BEAMS (30TH TO 37TH FLR.)

7 WORLD TRADE CENTER
NEW YORK

BOLTS 7/8"ø A325 HOLES 15/16"ø
PAINT SSPC SP2 (NO PAINT)
DRAWN BY: SF
CHECK BY D.Z. JULY 26/85
IN CHARGE OF FR
CONT. NO. C1275
SH. NO. 3076

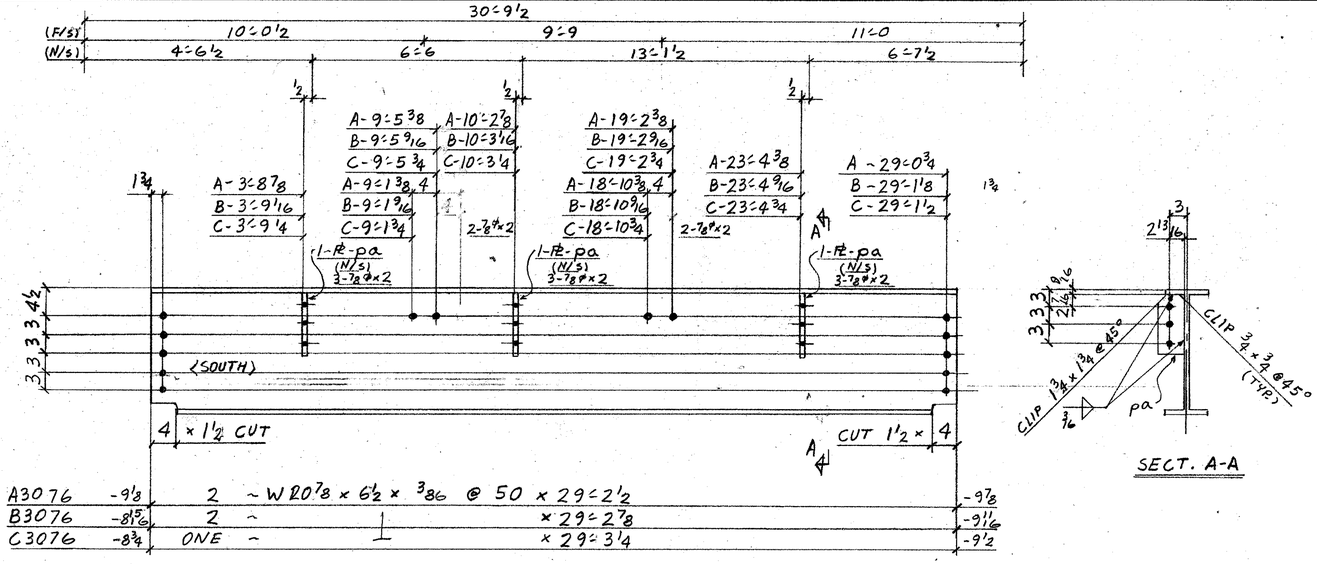
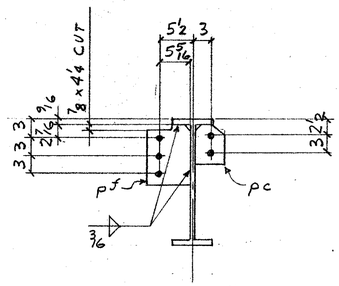
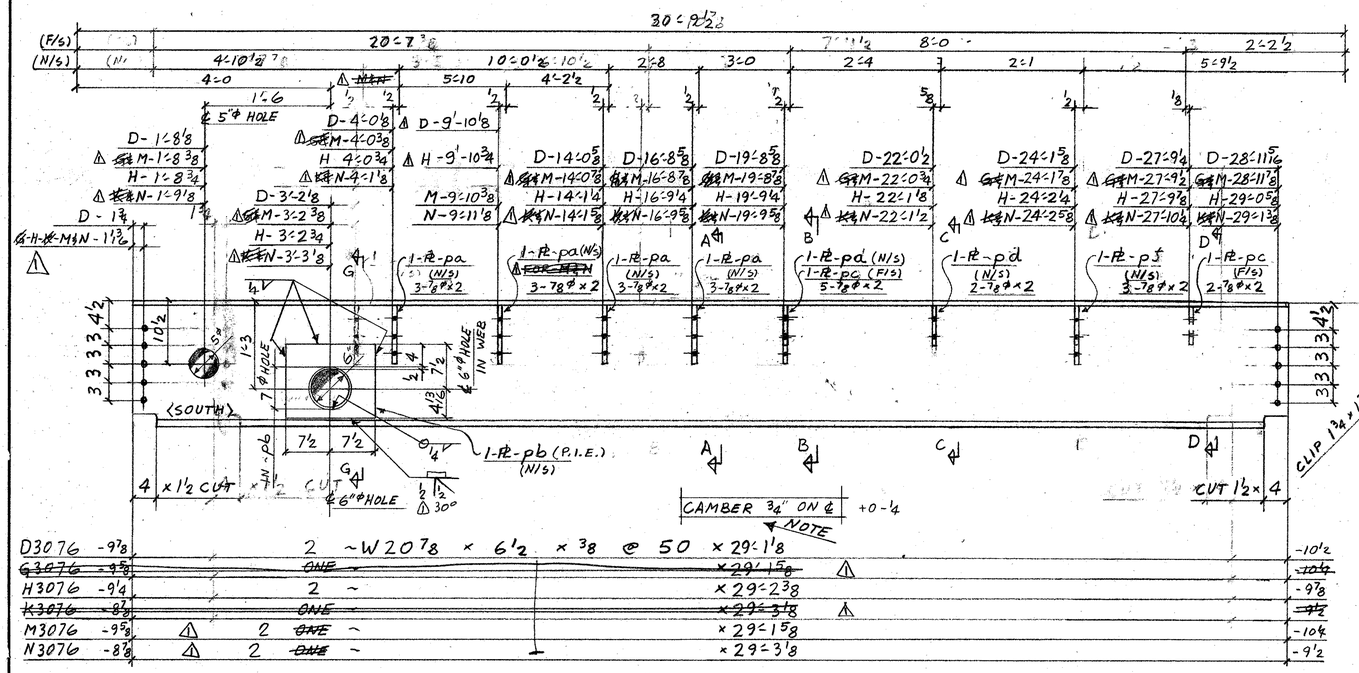
MARK / DW.	3108	3308	3508	3708
A3076		2		
B3076			2	
C3076				1
D3076	2			
~~G3076~~		~~=~~		
H3076			2	
~~K3076~~				~~=~~
M3076		?=		
N3076				?=

REVISIONS
1 BEAMS G & K CANCELLED BEAMS M & N QUANTITY REV. BEAMS D & H CONNECTION ADDED D.Z. AUG. 29/85
